PUBLIC WORKS COMMITTEE AGENDA

PUBLIC WORKS COMMITTEE MINUTES (DRAFT)

THOUGHTS FROM ADA WALKABOUT TOWN OF SHEPHERDSTOWN JEFFERSON COUNTY, WEST VIRGINIA

TECHNICAL ASSISTANCE REPORT

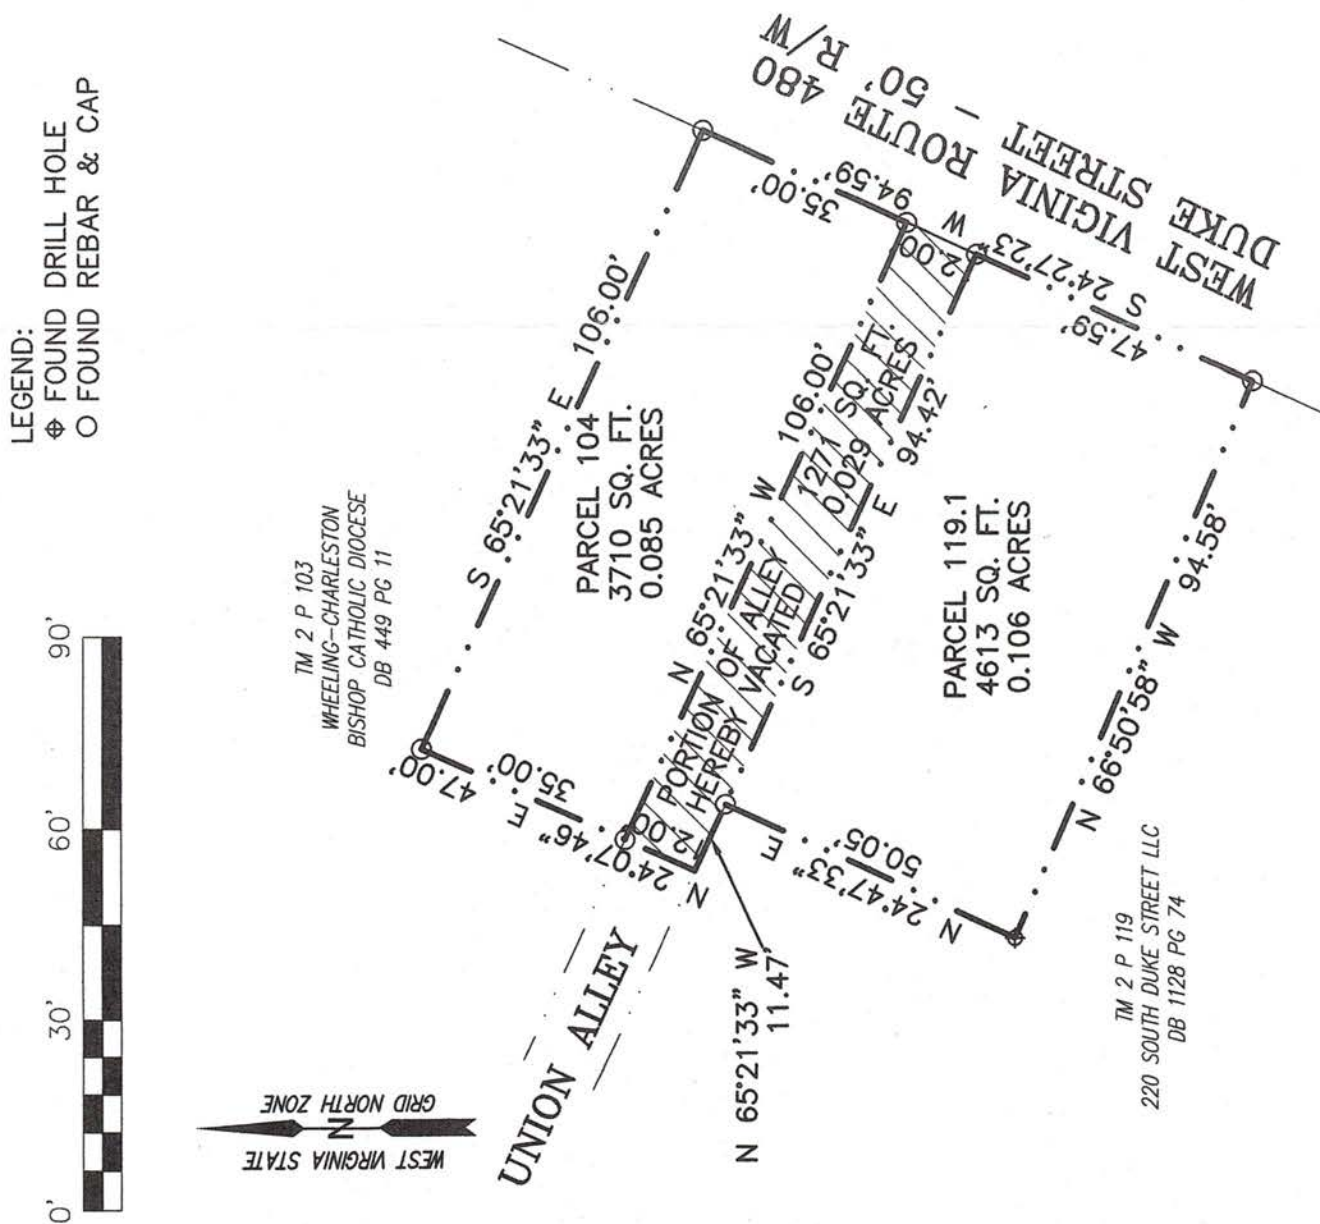
Owners (names?) have asked the Town sell them an easement strip that separates their two (2) parcels. See attached Plat. They have maintained this area, and the desire to have just one (1) tax parcel. This area does not provide access. FW – this request was made before and turned down as this area could provide utility access. Committee to research.

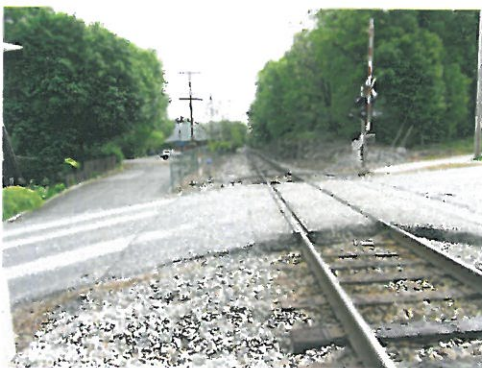
However, the resurfacing resulted in the ramp on the north side of E. German being removed. In addition, the crosswalk striping was not renewed. Note that, as shown here, the signing of this location (pedestrian warning sign with a downward arrow) indicates that this is a crosswalk. The arrangement is confusing and raises liability concerns. The situation should be discussed with the WVDOH. If nothing else, it appears that the downward arrow plaque should be removed.
